Access Compliance Report

Public Rights-of-Way

(Pedestrian Signals)

Intersection ID: N/A	Main Street:	Cross Street: N/A	Location: N/A
ADA ID: 36F07D342AF6	Signal Type: Two Push Buttons-Non APS	Overall Compliance: No	Severity Score: BTN 1:N/A BTN 2: N/A No BTN: N/A
Codes/Mitigation Info/Possible Solution		Field Measurements/Component Compliance

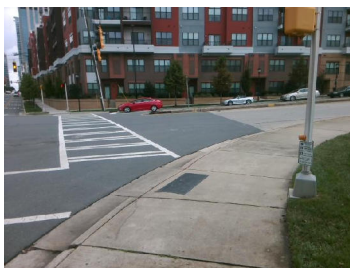
Possible Solutions: Replace Signal Push Button With APS Button on New Post. Remove & Relocate Sign.

PROW/ADA: TMUTCD 4e.08, R404.2, R406.2, R404.3
